Addendum No. 2

Project: Eagle Place Apartments **Project No.:** 1707.01
Subject: Addendum No. 2
Date: August 14, 2017

Roof Plan
 1/8" = 1'-0"

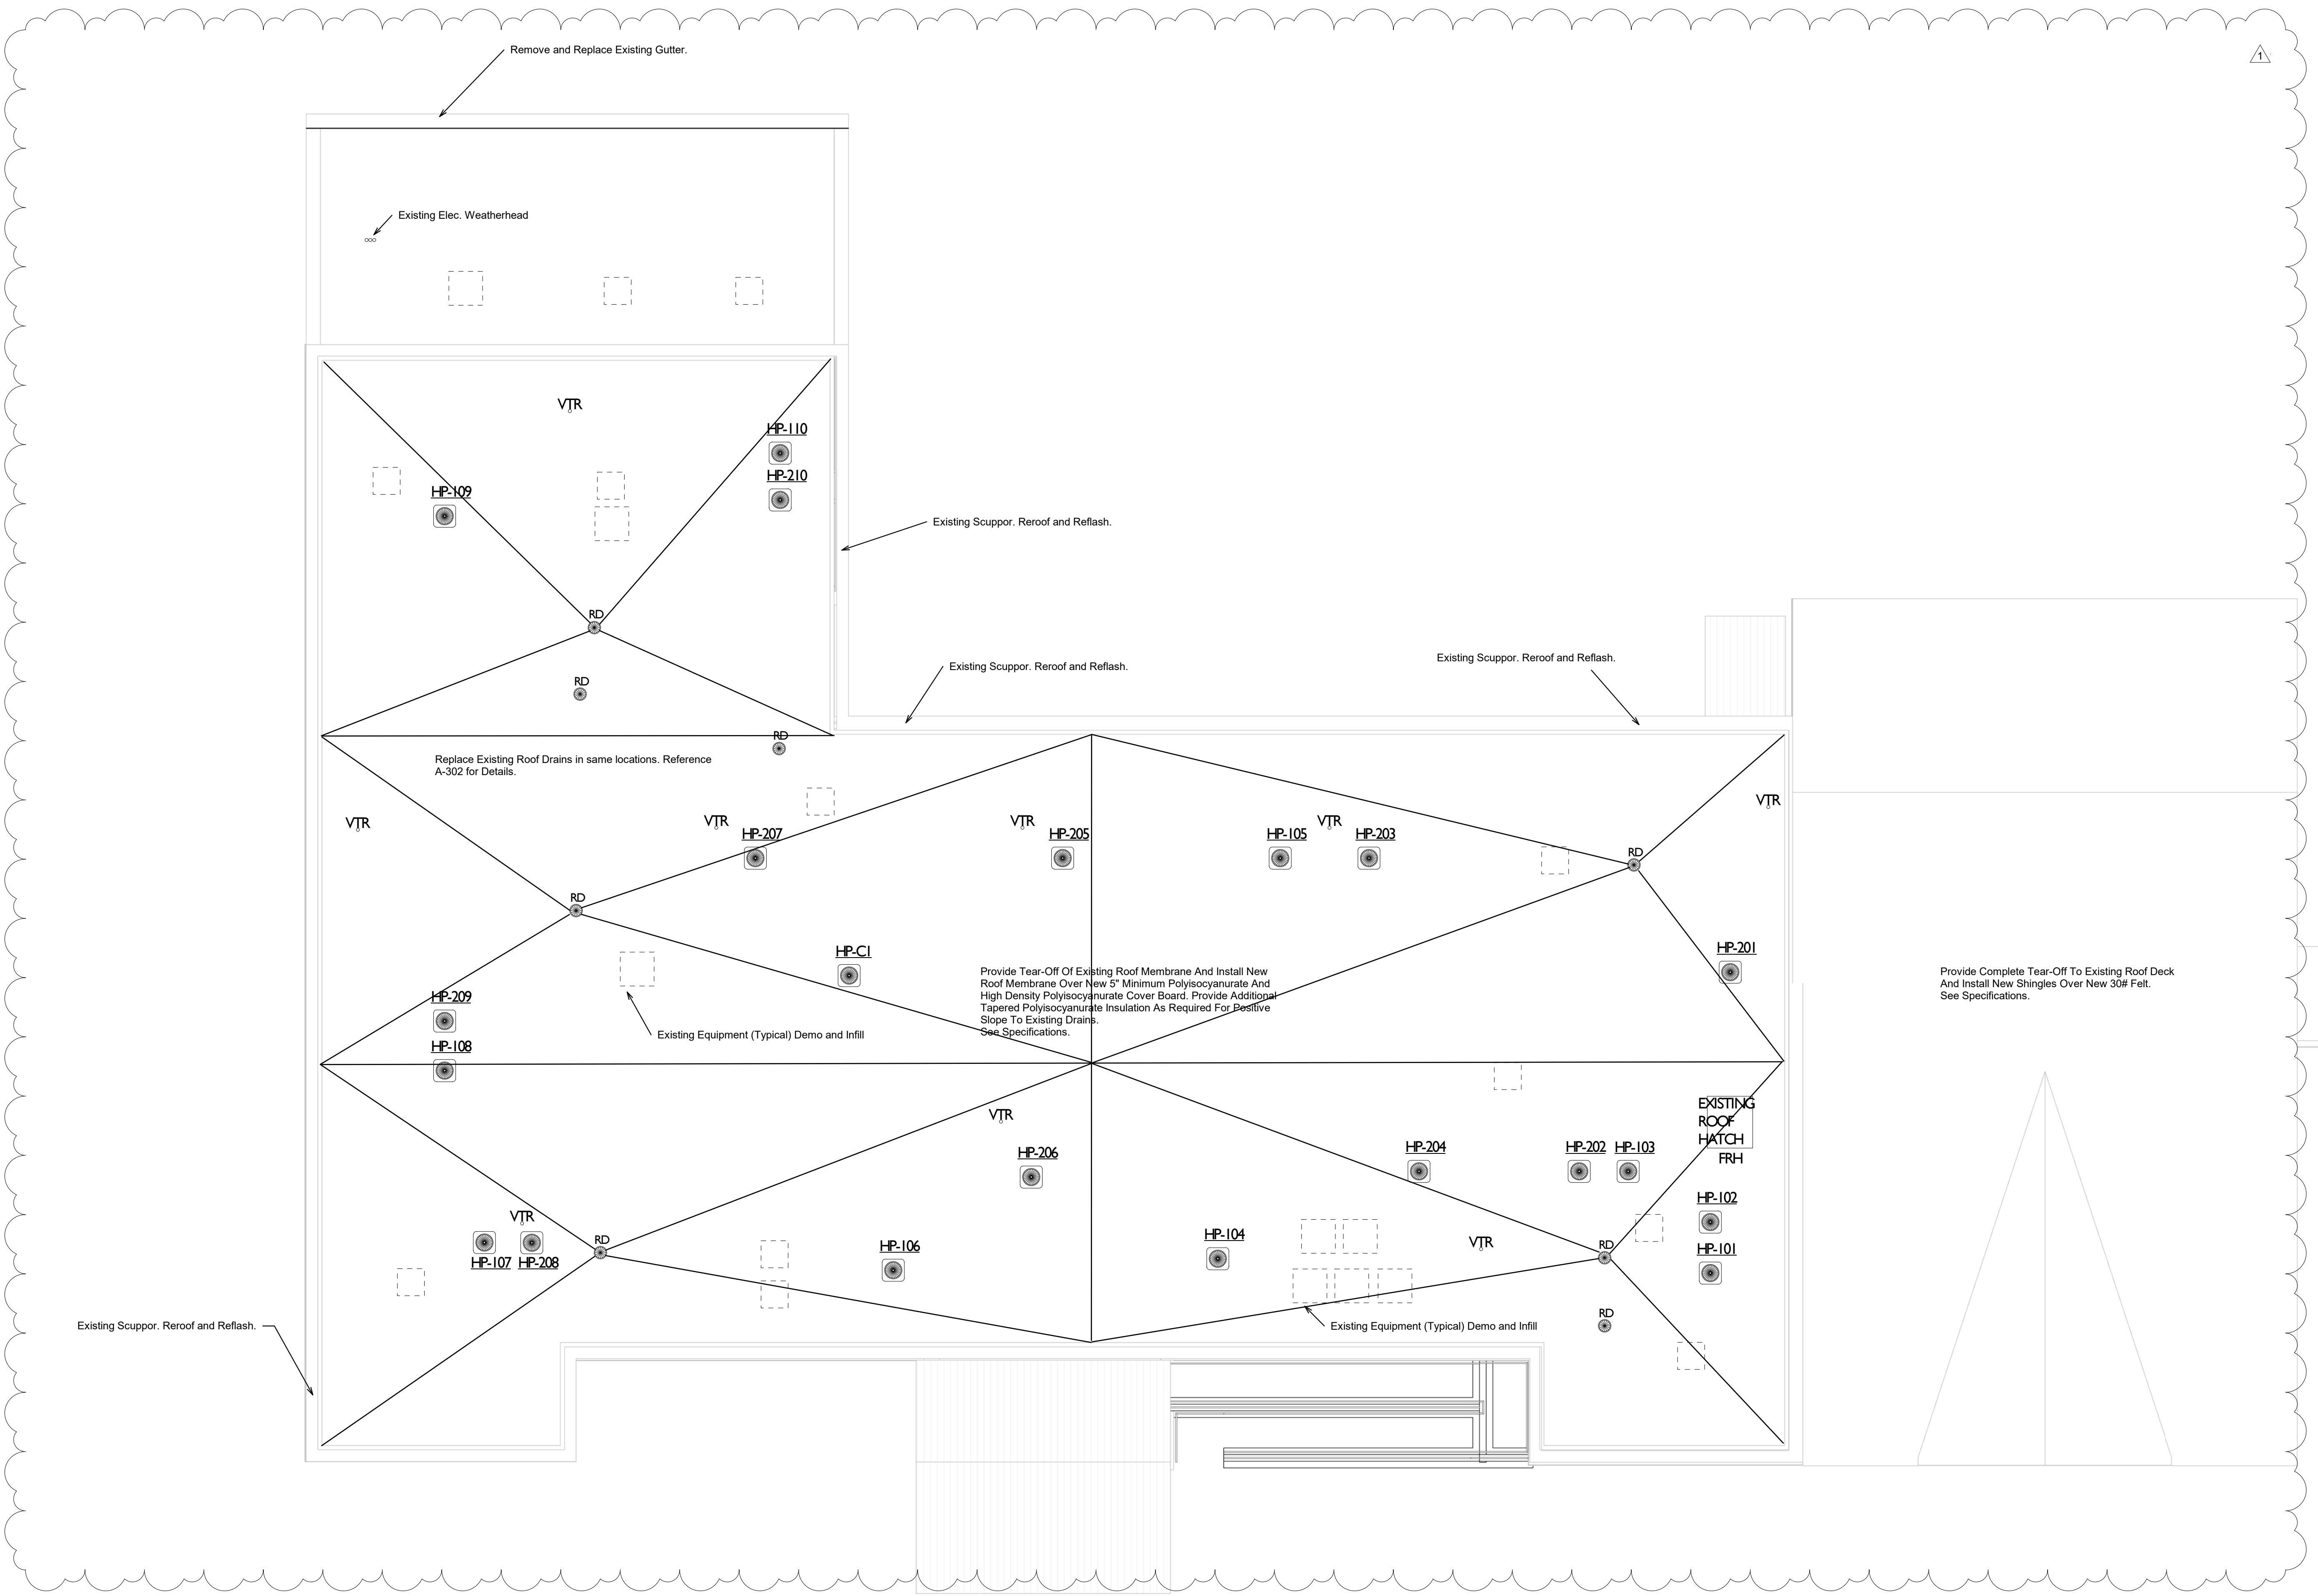
25. Drawings A101 & A102: In the Symbol Legend, the window identification sheet reference should be A501, not A803.
 26. Drawing A301: This drawing is reissued and included as a part of this addendum. For purposes of bidding, the existing roof deck is assumed to be flat (no slope) and all existing roof drain locations to remain.
